Technical Bulletin

Model 911SC, 928S	Group 00
Part Identifier N/A	Number 83-01

Subject: Location of VIN Label

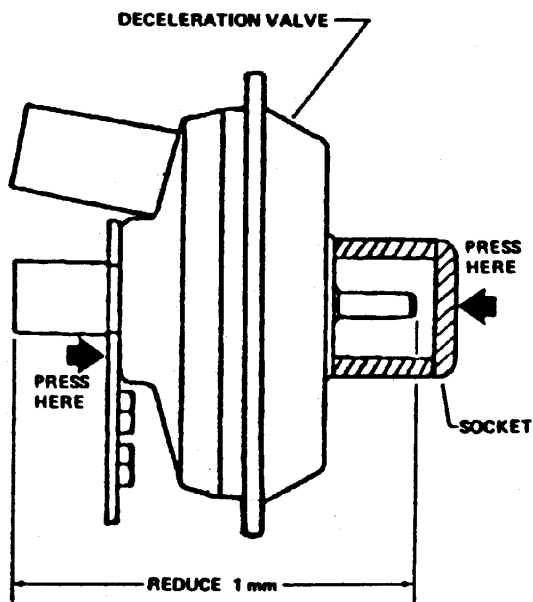
At lower ambient temperatures, engine idle speed can be unstable due to adjustment tolerances.

- Adjust ignition timing at operating temperature to 5°BTDC (vacuum hose disconnected).
- Adjust idle RPM at operating temperature to 850 RPM.
- Adjust CO at idle to $0.6 \pm 0.2\%$.

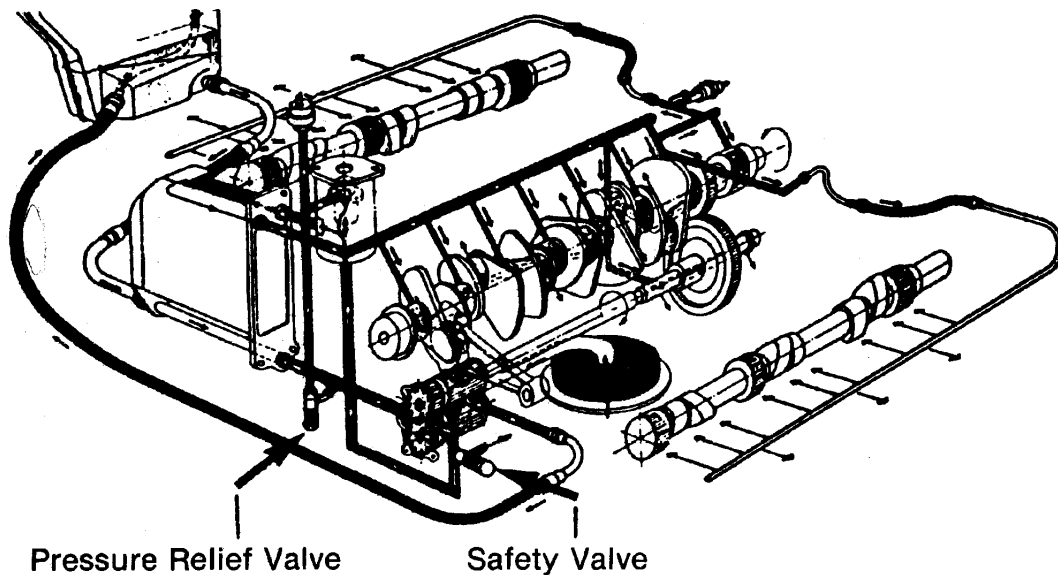
Oil pressure relief and safety valve springs and screws were modified during 1978 model year beginning with engine numbers as follows:

If oil pressure and oil level drop suddenly during high-speed driving, and 1978 vehicle engine number is prior to those listed,

— replace Safety Valve and Pressure Relief Valve parts with new parts shown

Wiring Diagram Type 911 Carrera Model 89 Sheet 5

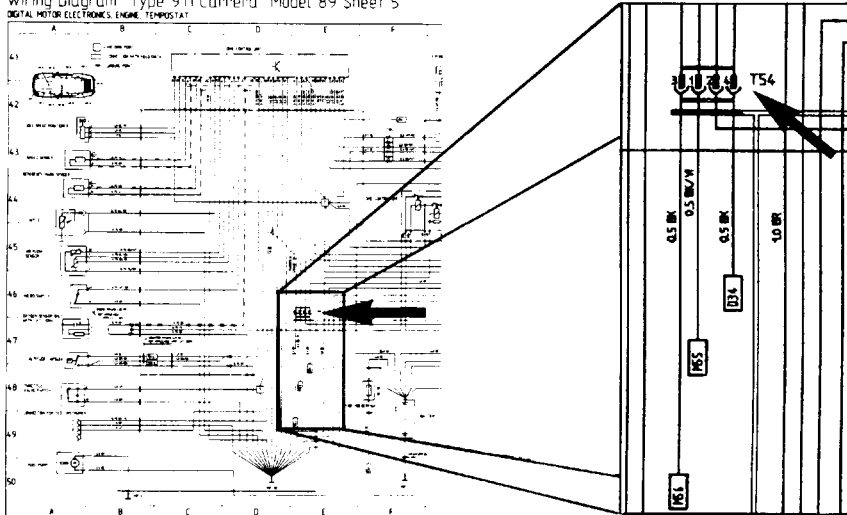
Concern: Repair Manual Wiring Diagrams, Model 1988, Sheet 5, Field E46
 Repair Manual Wiring Diagrams, Model 1989, Sheet 5, Field E46
 Wiring Diagram Book 1988 PNA 000 061, Sheet 6, Field E46
 Wiring Diagram Book 1989 PNA 000 066, Sheet 5, Field E46

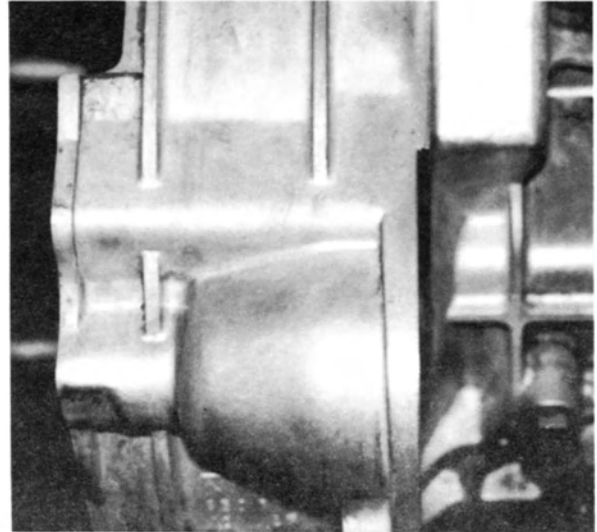
To assure good starter engagement, the engine mounting flange/starter motor mounting flange dimension on the 1987 Model 911 Carrera transmission housing was reduced from 117 - 0.2mm to 115 - 0.2mm (see picture).

Figure 2 (Old Version)

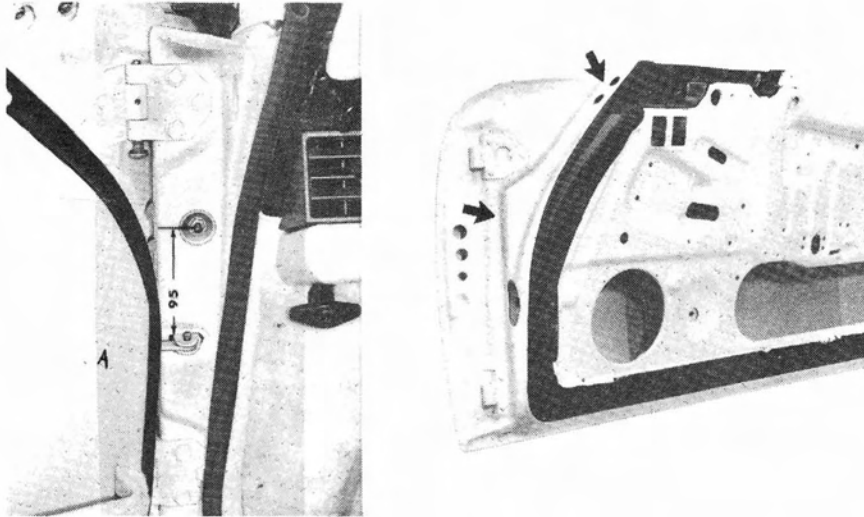
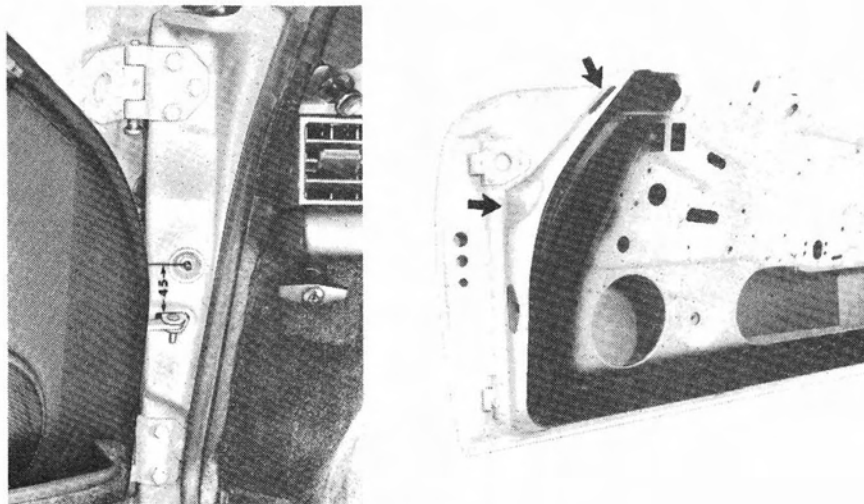
This requires drilling a new hole, 8.4 mm diameter, 50 mm below the old door contact switch hole (Figure 1). Deburr edges of the new hole and treat edges with rust preventing paint. Relocate switch into new hole. Install plug PN 911 531 999 00 in old hole.

Field coordinate M50

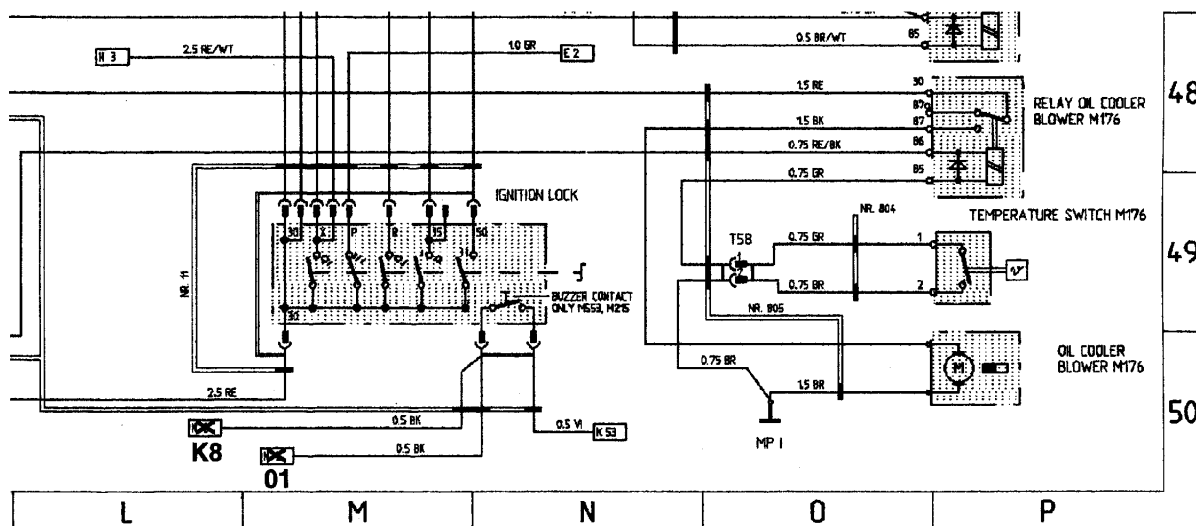
Connection with field indication N2 should read 01

Please correct your wiring diagrams.
